Tallawang Solar Farm

SUBMISSIONS REPORT

Prepared by Umwelt (Australia) Pty Ltd
on behalf of RES Australia Pty Limited

Project Director: Malinda Facey
Project Manager: Marion O'Neil
Report No.: 21139/R15
Date: May 2024

FIGURE 3.1

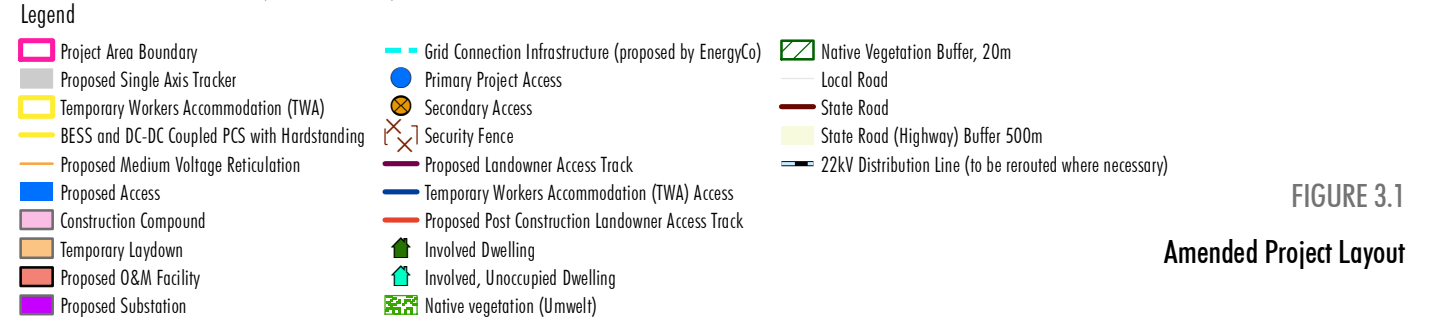
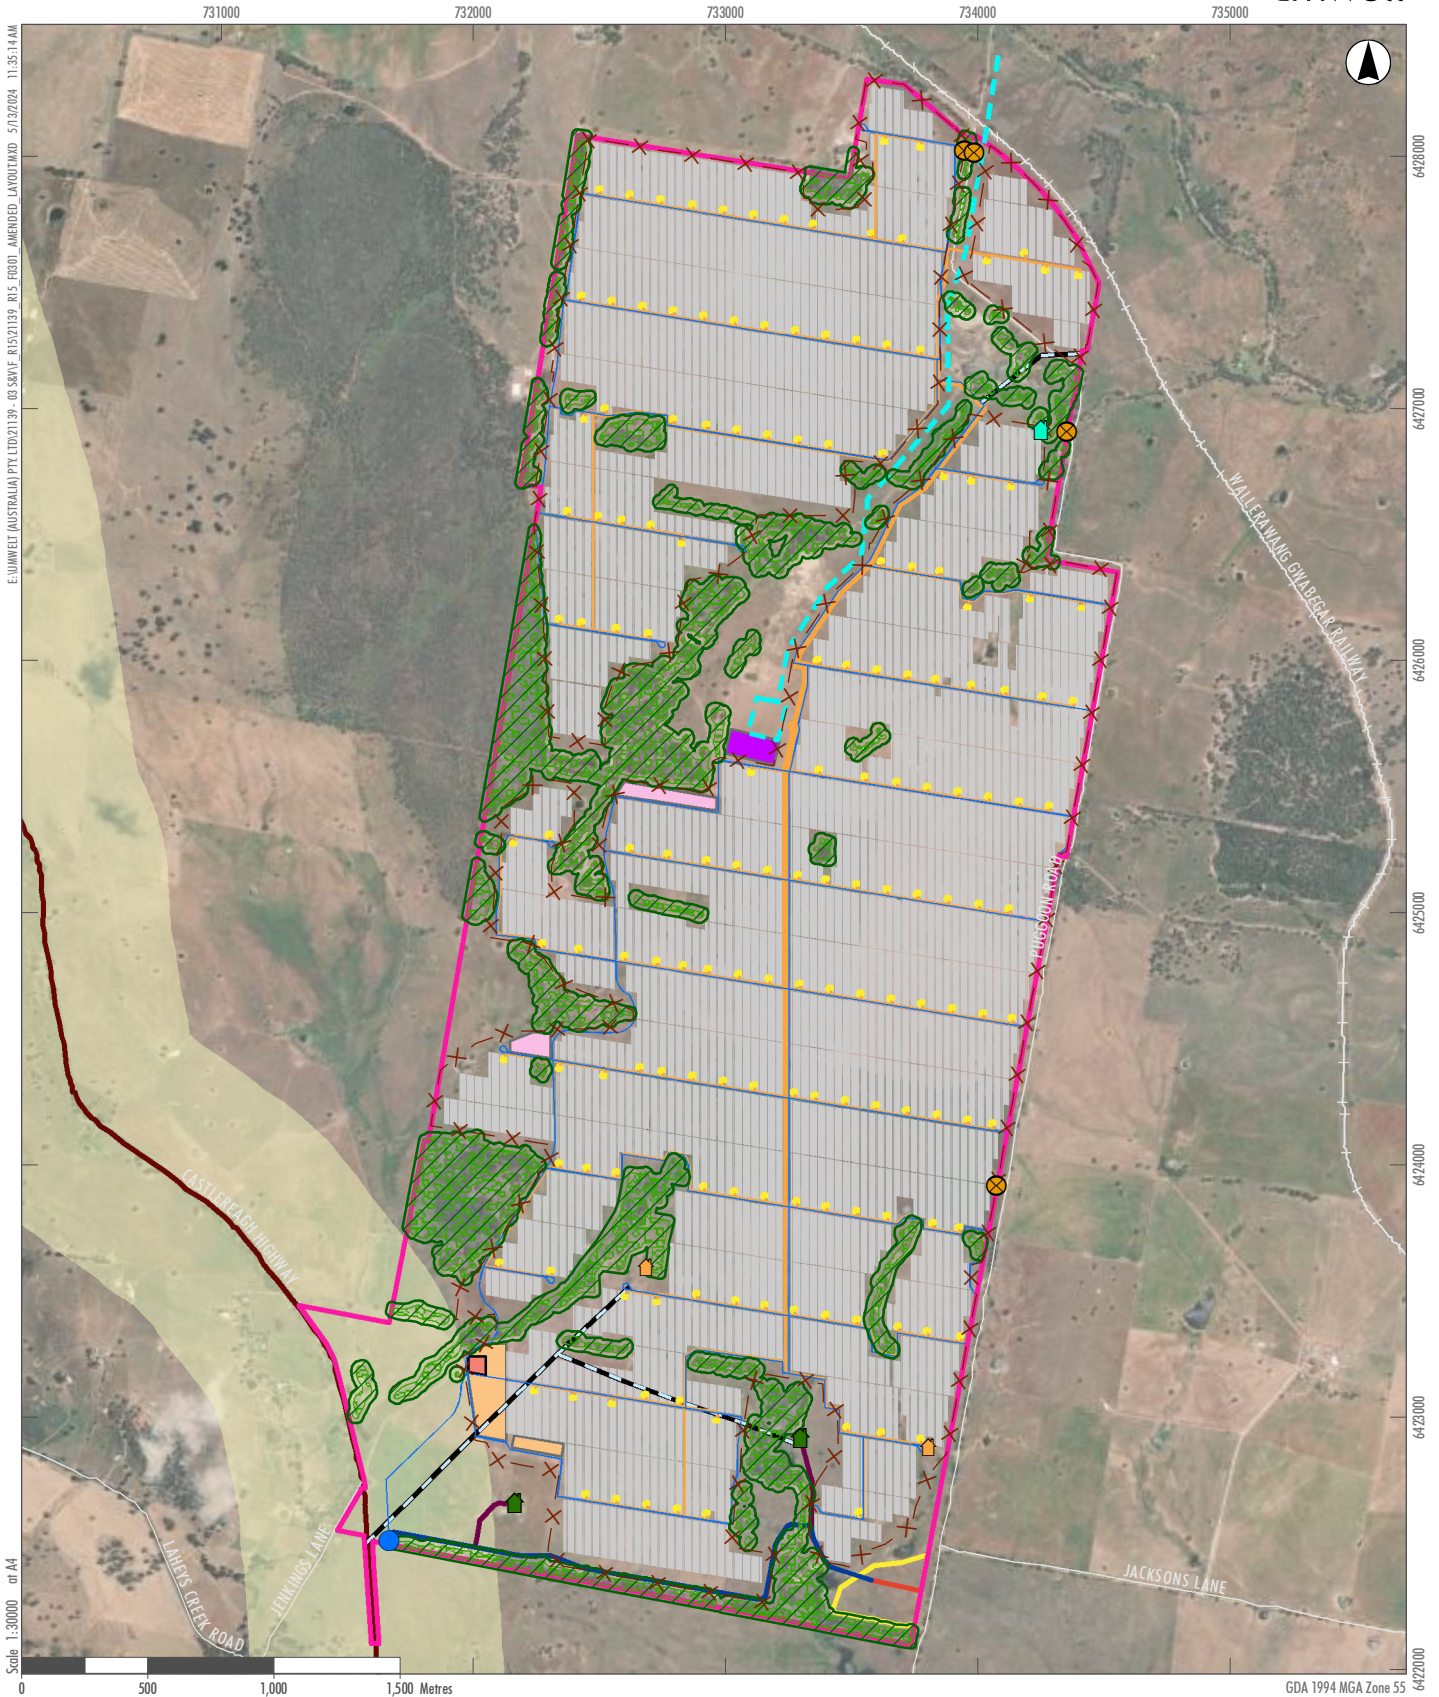
The submitted PHA does not provide the separation distance between individual DC-couple BESSs. Please provide the separation distances between individual DC-couple BESS layouts shown in Figure 1.3 of the PHA. This information will support the credibility of fire escalation between individual systems;

As noted above, the BESS capacity for the Amended Project has increased and the Project layout has been amended (refer to **Figure 3.1**). This resulted in amended separation distances between the individual DC-coupled BESS units. A Preliminary Hazard Analysis (PHA) Addendum has been prepared to evaluate and assess changes to the hazards and risks as a result of the Amended Project (refer to Appendix 13 of the Amendment Report).

FIGURE 4.1

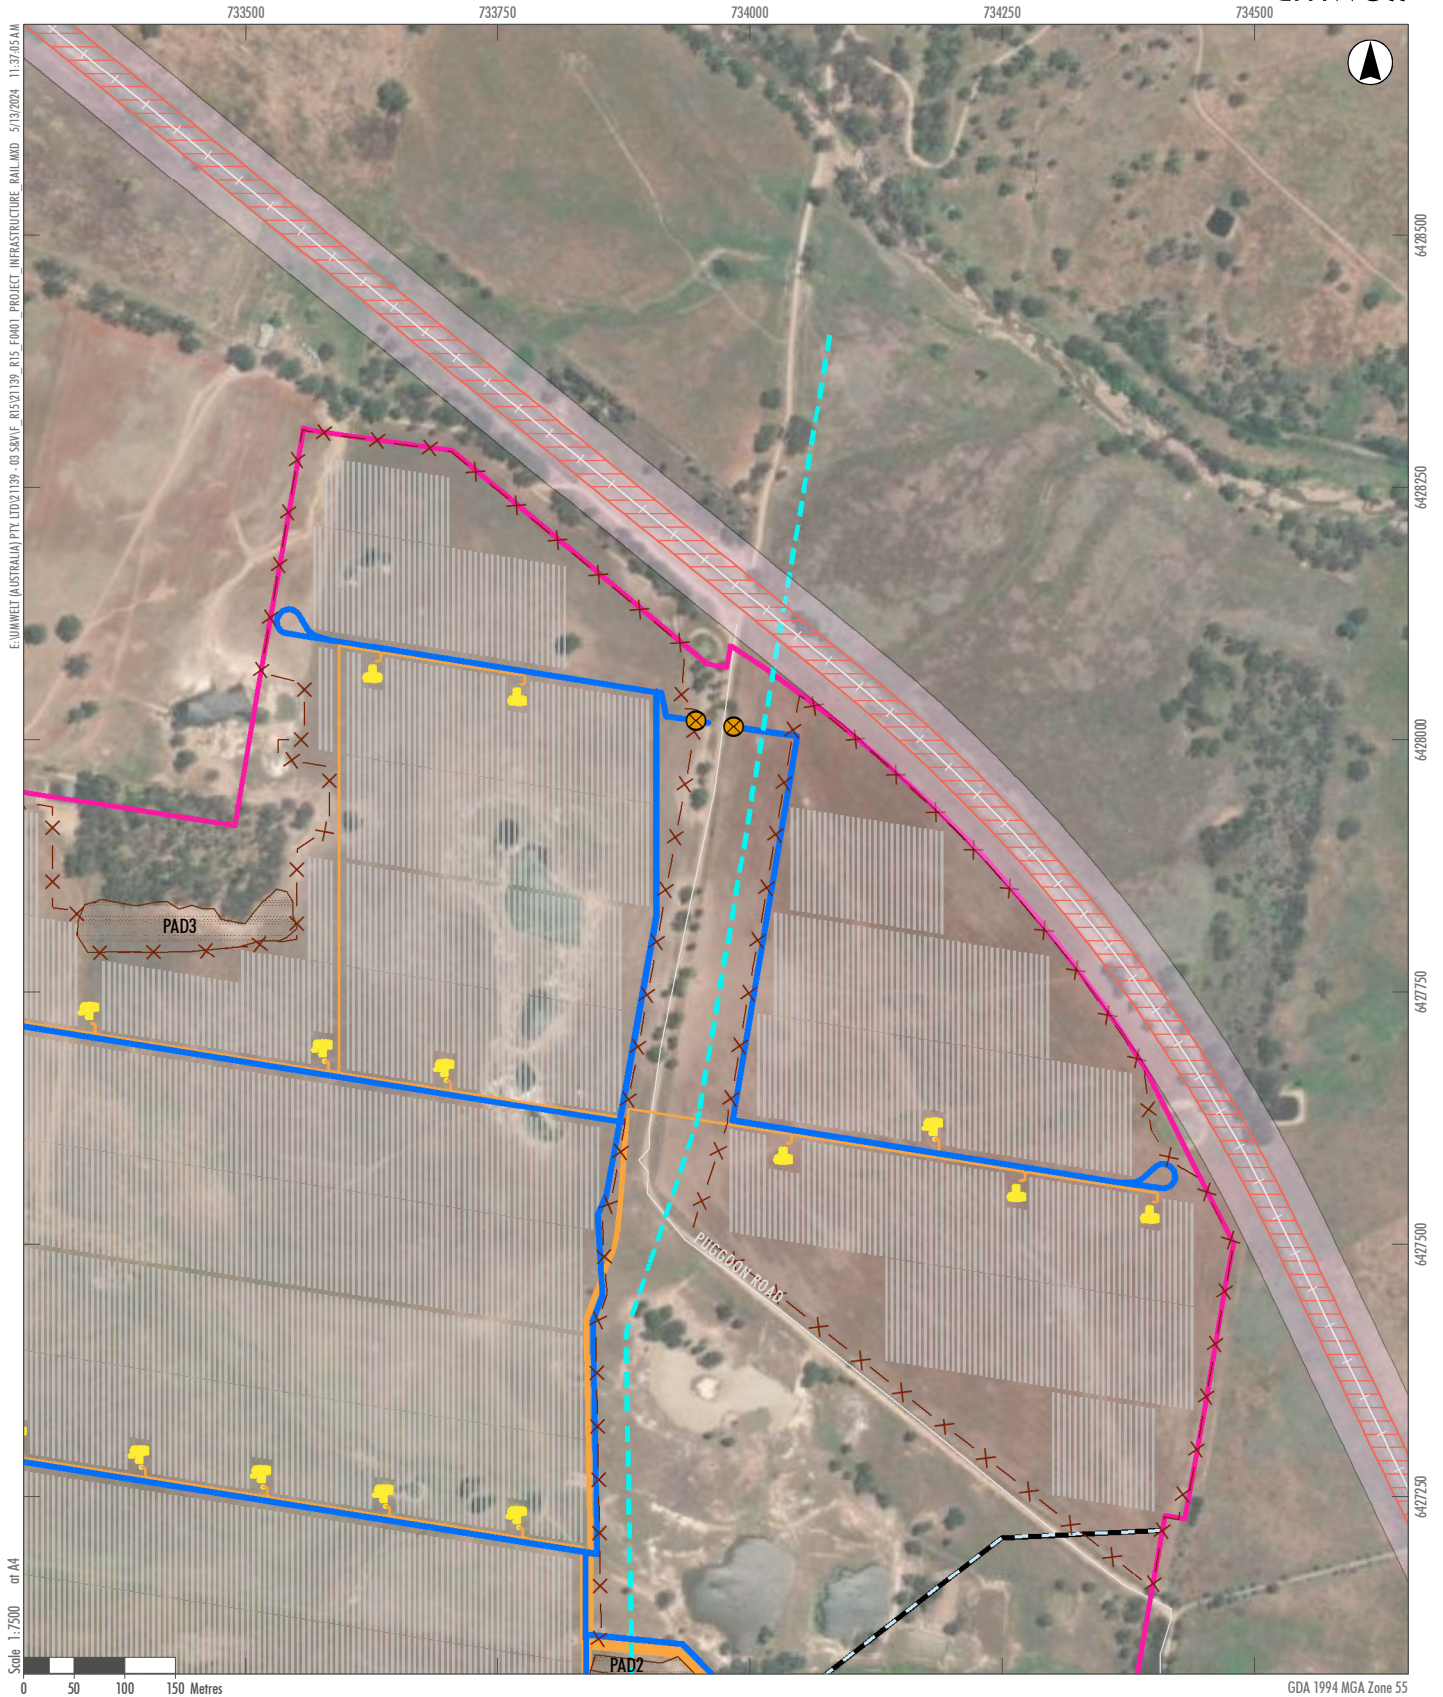
I advise that Australian Rail Track Corporation (ARTC) has no objections to the proposed Development, however ARTC requests that due to the nearby rail corridor, Department of Planning considers the following in its assessment of the application;

- *The impact this development will have on the level crossings.*
- *The installation of aerial power lines are completed in accordance with ARTC requirements.*
- *Due to the proposed development being within 25 m of the rail corridor, ARTC requests a greater understanding of all works adjacent to ARTC land.*
- *The proponent will be required to seek ARTC concurrence to carry out any works within 25 m of the rail corridor, including installation of powerlines, excavation and any other adjacent earthworks as it has the potential to impact on the safety and operation of the rail network.*

There is a section along the north-east boundary of the Amended Project Area that borders the Wallerawang Gwabegar Railway line, as illustrated on **Figure 4.1**. No Project infrastructure is proposed within 25 m of the rail corridor.

FIGURE 4.2
Watercourse Setback Distance

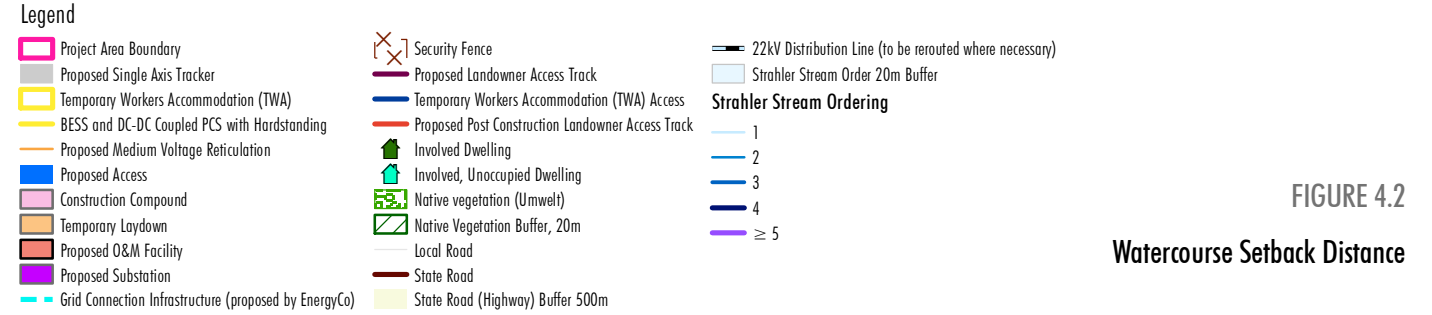
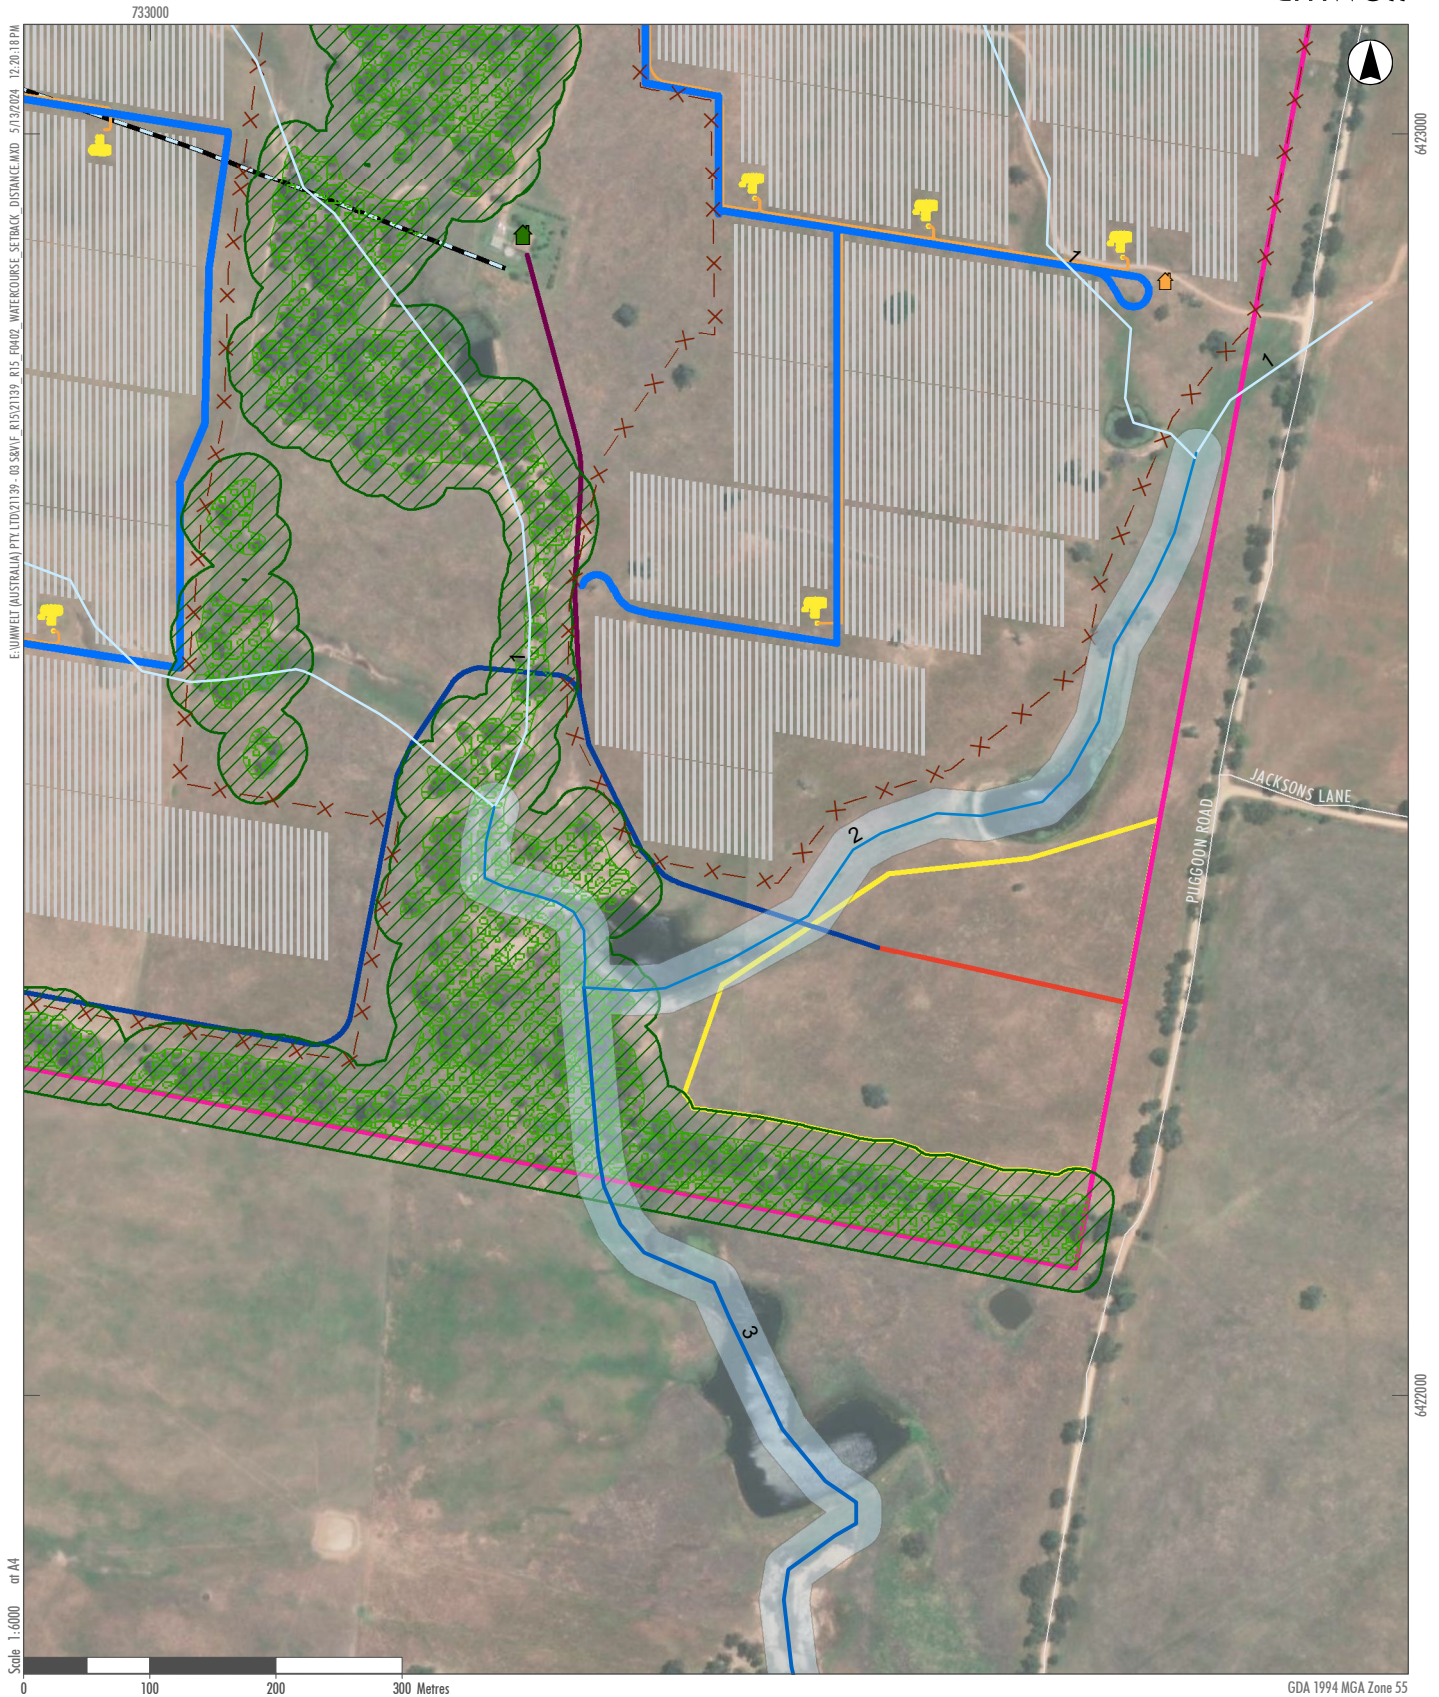
<i>Controlled Activities: Recommendation – Prior to Determination</i>	<i>Controlled Activities: Explanation</i>
<i>The proponent should confirm that the 2nd order watercourse in the south-eastern part of the site has been provided with a setback in accordance with the Guidelines for Controlled Activities.</i>	<i>The EIS notes the setback of 40 m from watercourses with biodiversity values. While this generally appears to have been applied, confirmation is requested that a setback for the 2nd order watercourse in the south-eastern part of the site has been provided in accordance with the Guidelines for Controlled Activities.</i>

The Amended Project Layout provides setback distances (ranging from 10 m to 40 m) around watercourses with biodiversity value. In particular, the 2nd order and 3rd order watercourses within the south-eastern part of the Amended Project Area have been provided with a setback in accordance with the *Controlled Activities – Guidelines for riparian corridors on waterfront land* (DPE, 2022) (i.e. a buffer of at least 20 m from the edge of the creek channel), as illustrated on **Figure 4.2**.
